Date of Issue: September 2015

Affected Publication: ANSI/API Specification 17D/ISO 13628-4, *Design and Operation of Subsea Production Systems—Subsea Wellhead and Tree Equipment*, Second Edition, May 2011

ADDENDUM

Page 228, Figure M.1, replace:

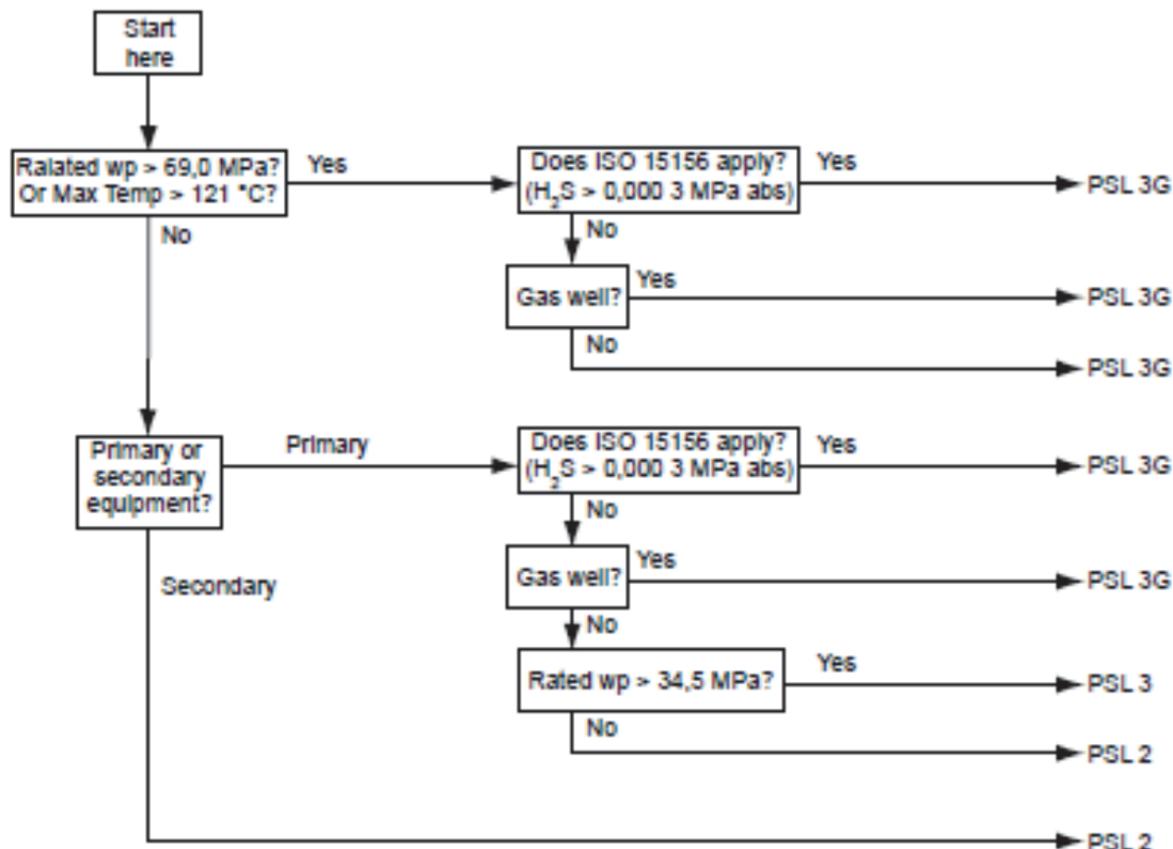
with
